**Subject:** Grid's 11/12/21 presentation

# Citizens MGP Site Remedy

November 12, 2021

# Mounding

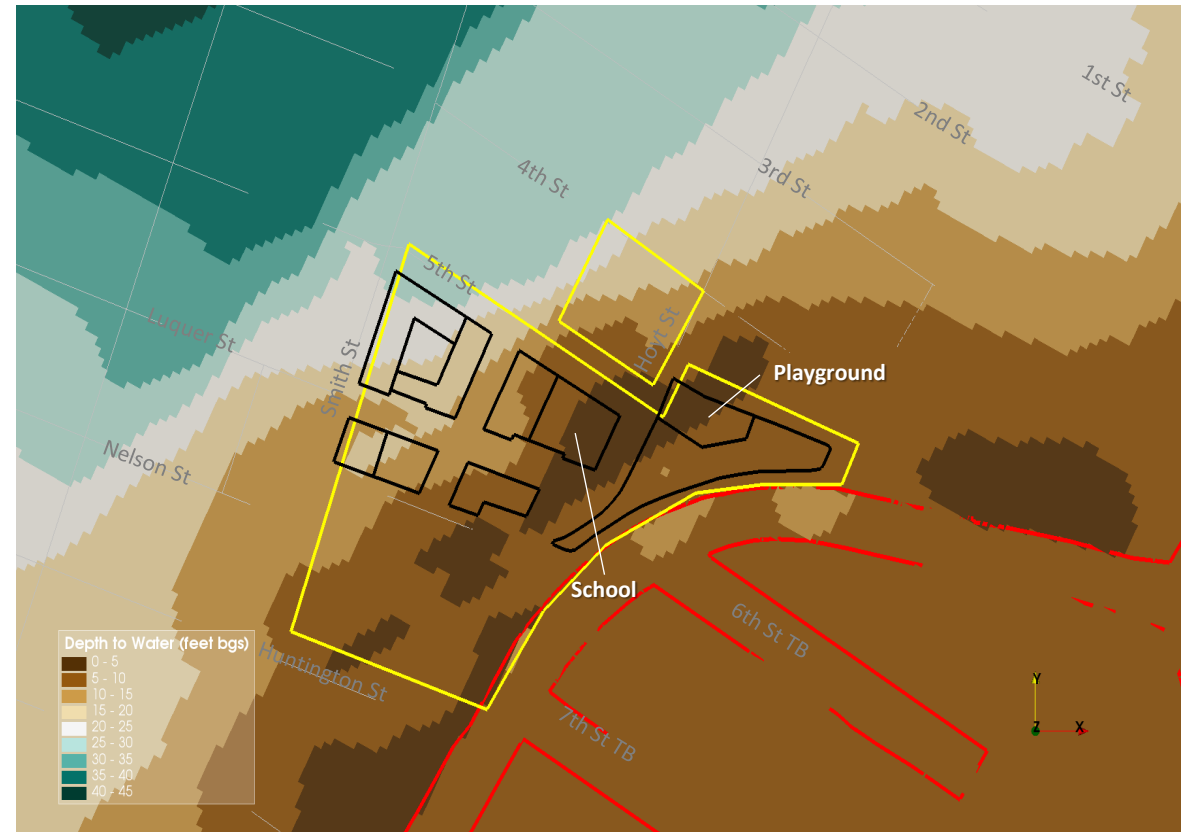
- Arcadis design addendum states that its intent is to relieve groundwater mounding “in the immediate vicinity of the wall”
- Groundwater model output show the limited dewatering extent of drain which is more in the playground area

# Subslab ventilation?

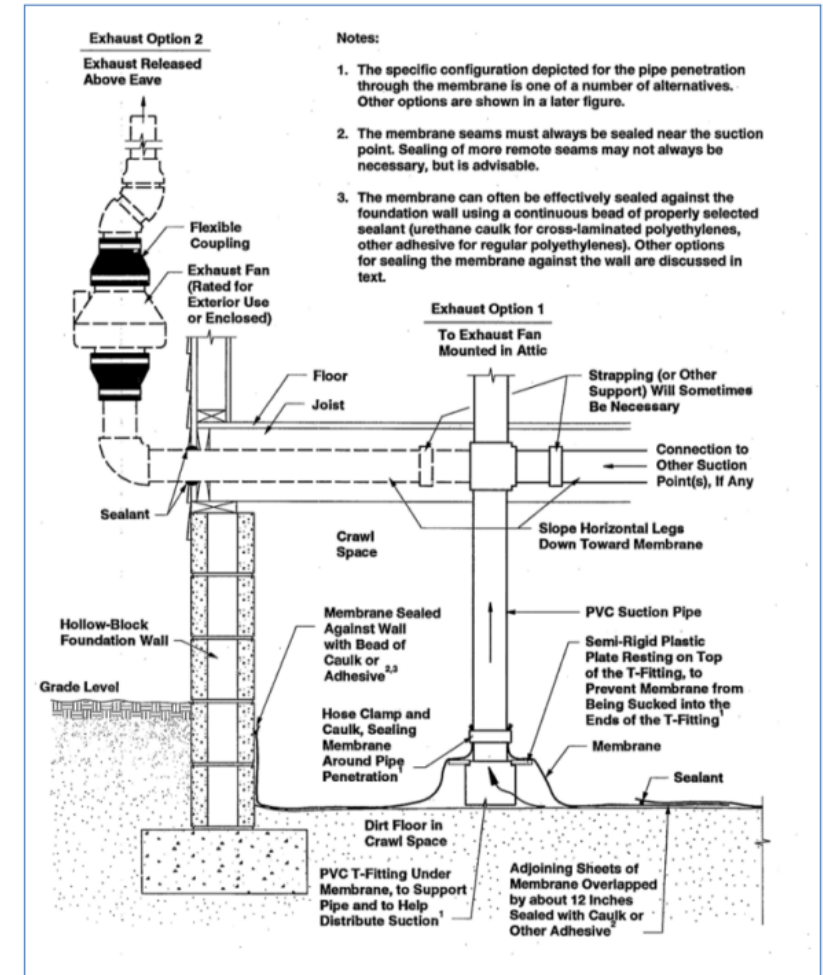
- Finished floor elevations do not account for subslab ventilation systems which will be deeper and need unsaturated conditions to operate effectively
- Should a target depth of groundwater be set if these type of systems are to be used.

# Shallow Groundwater BTEX from RI

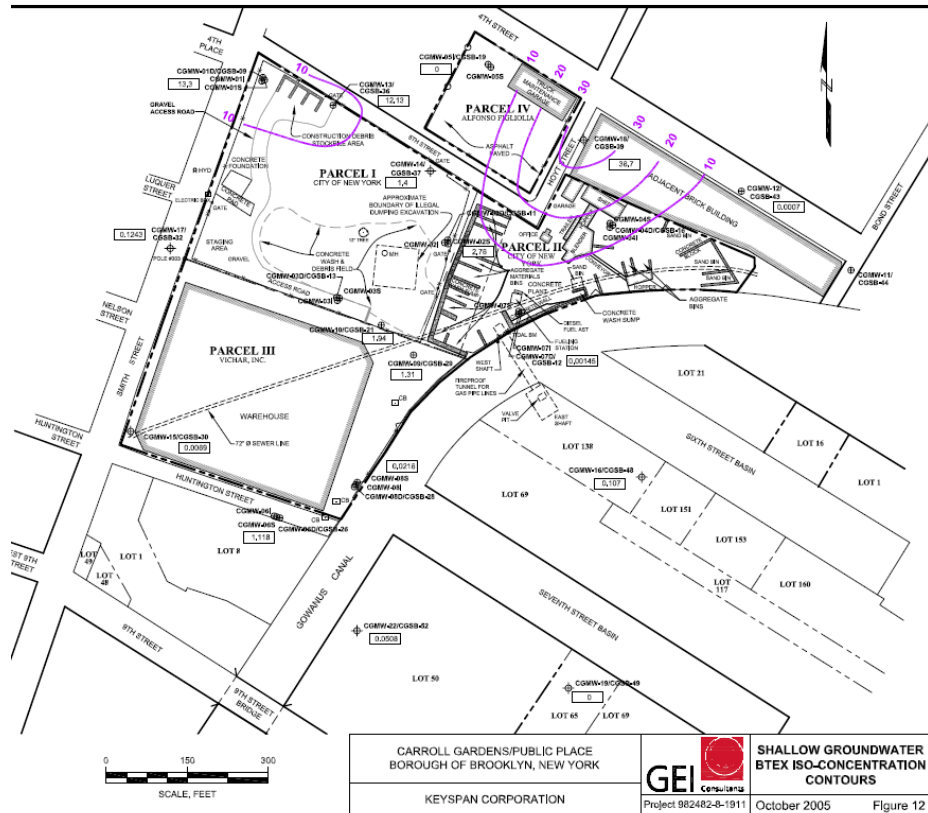
- Concentration are in mg/L not  $\mu\text{g/L}$  like the presentation figure
- Maximum concentration on Arcadis figure is 16 mg/L (MW-18) but the contour interval is 1 mg/L
- Source of data is unknown
- RI concentration at MW-18 was 36 mg/L

I believe that Grid was going to get us the info they used for the benzene in groundwater figure that they presented; that figure included data from 2016 that EPA and DEC had not seen before. National Grid recently submitted an off-site investigation report for the Citizens Site which is attached for reference. The report summarizes a compilation of off-site soil and groundwater data. Much of this data is from the original 2005 RI but the report also includes supplemental data from as recently as 2015. In addition, please see attached excel data table that Grid used as the basis for the benzene gw figure.

The NYSDEC shares the same concern as EPA regarding the basis for this groundwater figure. From review of the off-site investigation report it was observed that two of the pertinent wells, CGMW-24 and CGMW-25 were listed as “not sampled”. Grid indicated that those wells were unable to be sampled due to insufficient groundwater being present in the well. Therefore, the DEC has requested additional off-site sampling to inform current gw conditions. National Grid is proposing to over drill/replace monitoring well CGMW-25 and re-sample. Note that this well is located across Smith Street from Parcel I and its data will help to address EPA’s concern about shallow groundwater in this area. This work has not been scheduled yet, but will be completed in the near future.

# Total PAH Flux (mg/m<sup>2</sup>/year)

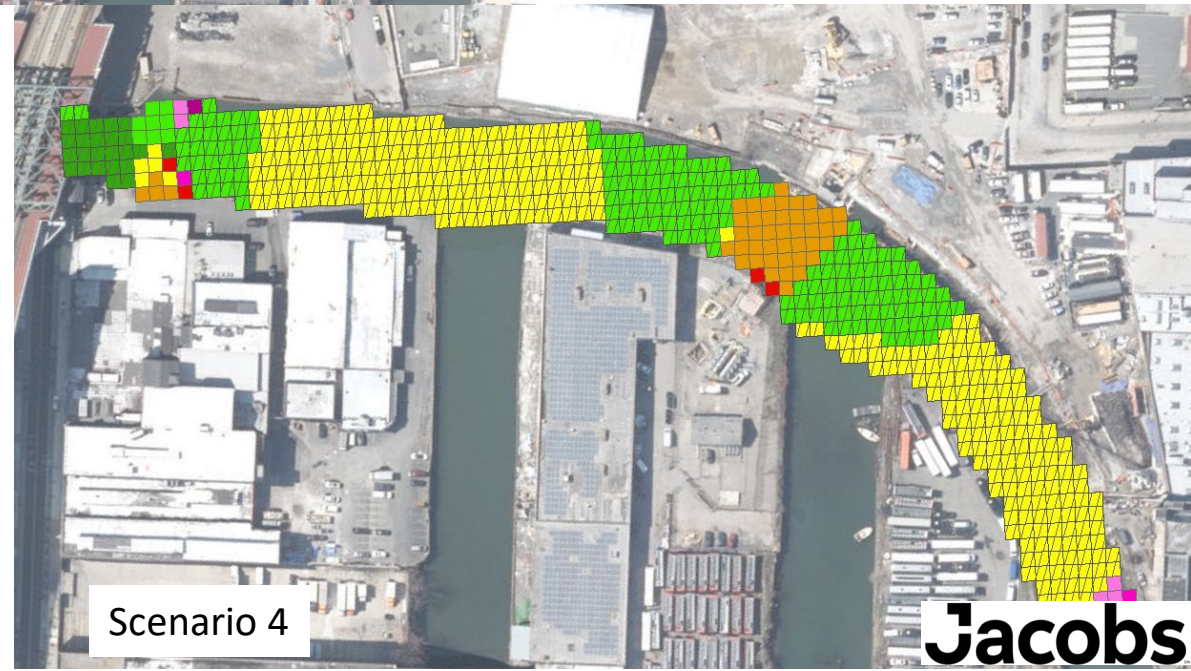
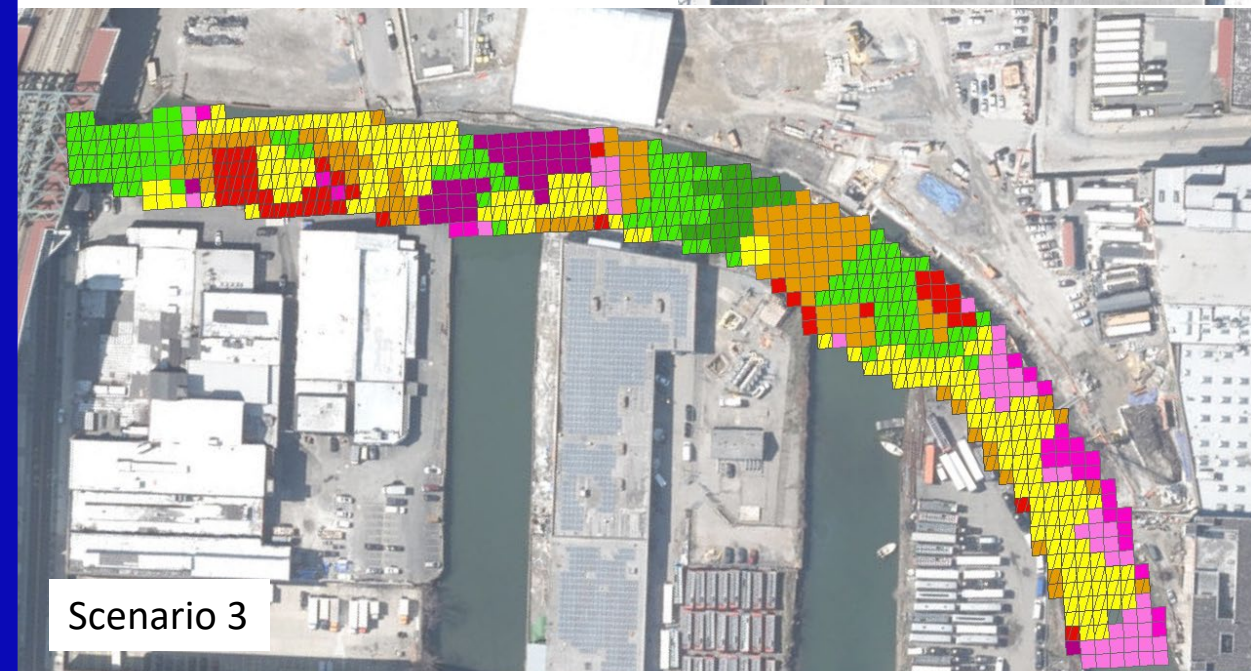
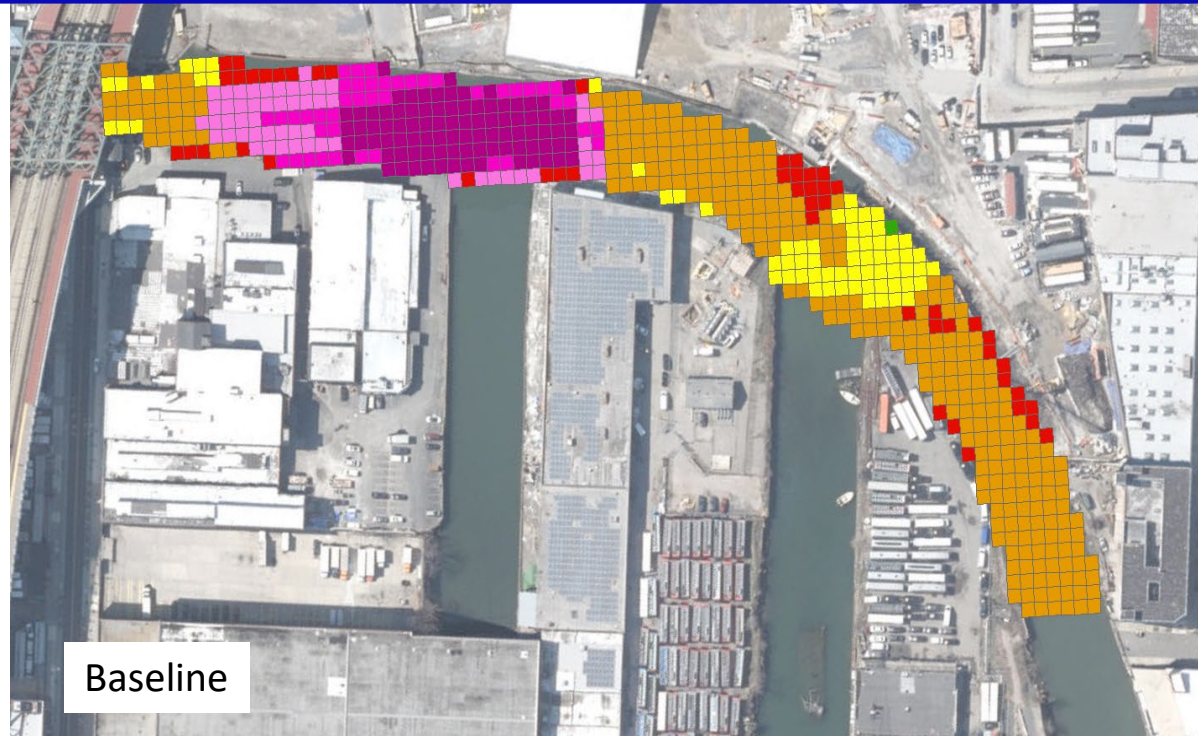
- 70-inch dissolve phase treatment layers needed to treat the PAH flux in areas outside of the ISS areas

- RP Group concern thickness and proposed Scenario 4

# Intermediate Zone NAPL Impacts

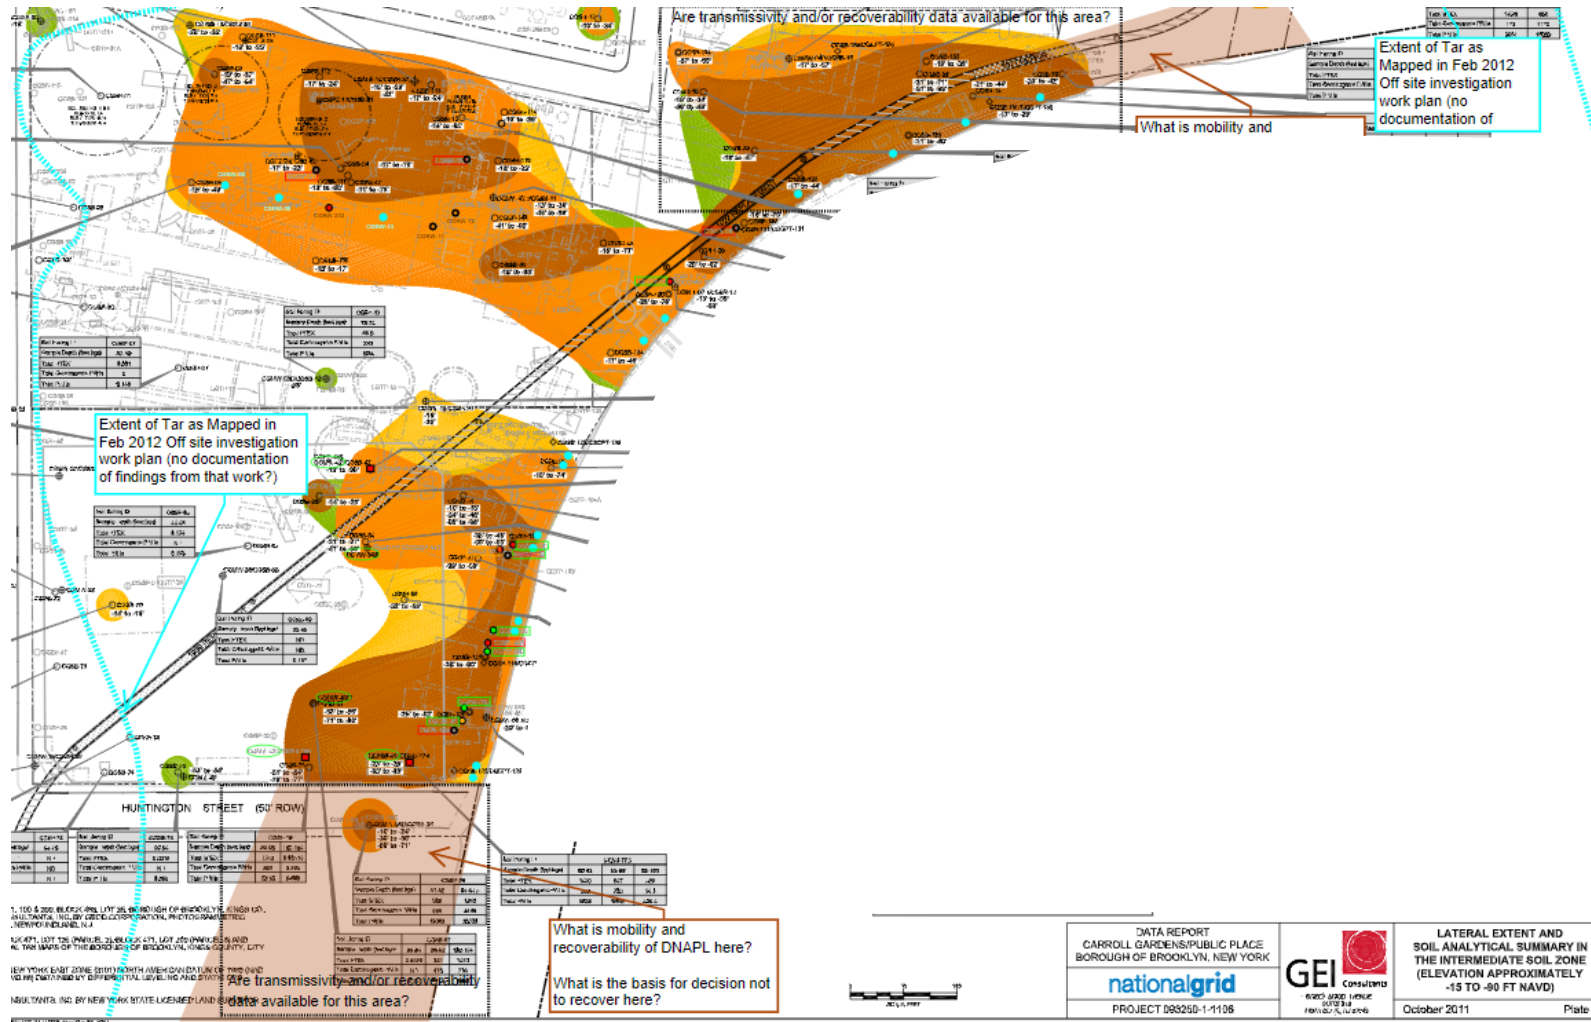
- What is DNAPL recoverability across the entire area
  - Property boundary areas most of a concern
- Recovery wells locations do not address entire NAPL area
